Proposal for amendments to ECE/TRANS/WP.29/GRRF/2015/27

Part A – Amendment to UN Regulation No. 54

Paragraph 3.1.10., amend to read:

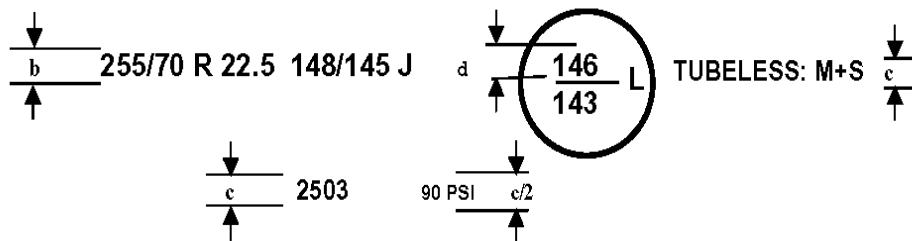
"3.1.10. An indication, by the "PSI" index, of the inflation pressure to be adopted for the load/speed endurance tests, as explained in Annex 7, Appendix 2. However, this indication, which it is permissible to restrict to one sidewall, shall not be mandatory, on any tyre submitted for approval, until two years after the date of entry into force of this Regulation.⁵

For tyres first approved after 1 January 2018, the inflation pressure for the dimension measurement and for the load/speed endurance test, pursuant to paragraph 4.1.12 of this Regulation, shall be indicated in kilopascals, replacing the "PSI" index.

kPa marking instead of PSI may be used for tyres first approved before 1 January 2018. "

Annex 3, replace:

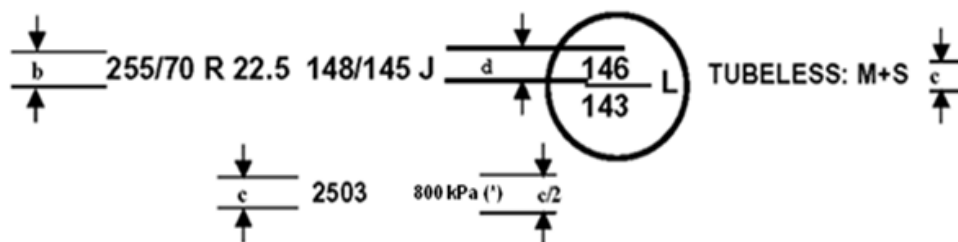
(*) PSI marking instead of kPa may be used for tyres first type approved before 1 January 2018. "
